**Draft Sydney Development Control Plan
2012 - 923-935 Bourke Street, Waterloo
(as amended following public exhibition)**

923-935 Bourke Street, Waterloo
~~November 2022~~ **August 2023**

Figure X.X: Tree Retention and Protection

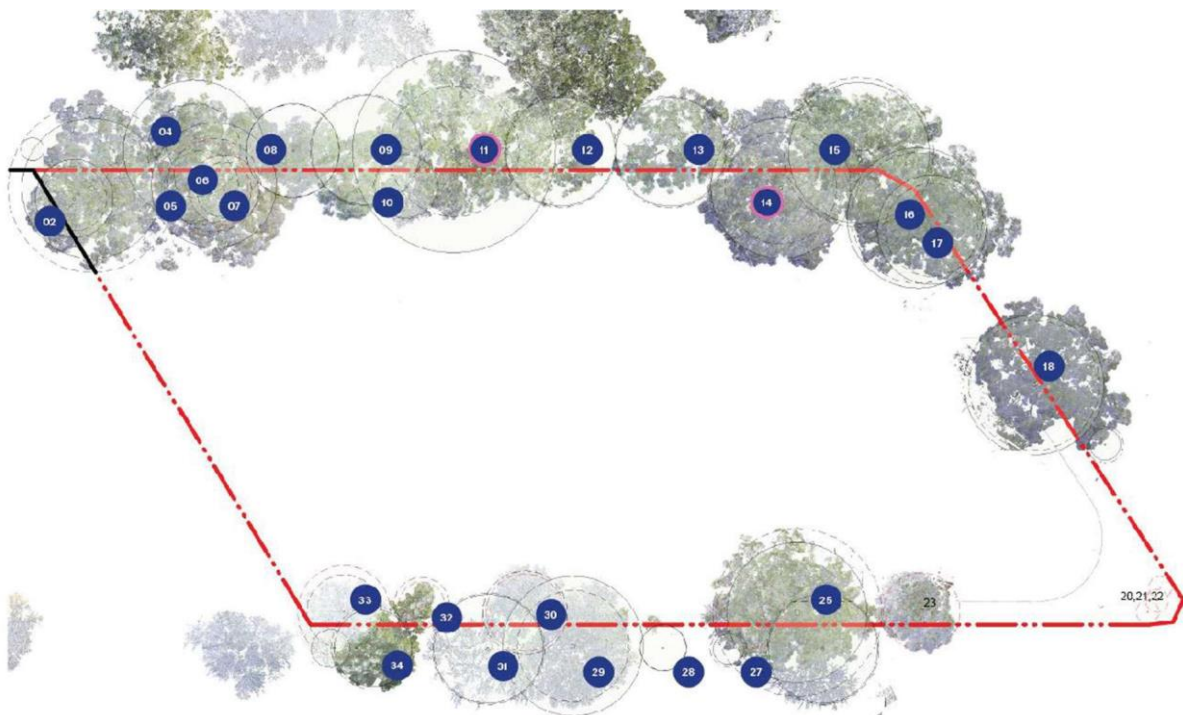
- (1) Retain and protect trees, both on the site, and the surrounding street trees, in accordance with **Figure X.X: Tree Retention and Protection**.

- (2) Trees identified in **Figure X.X: Tree Retention and Protection** must be retained and protected. Trees that may be removed or significantly pruned (numbers) are 05, 07, 20, 21, 22, 23 and 32.
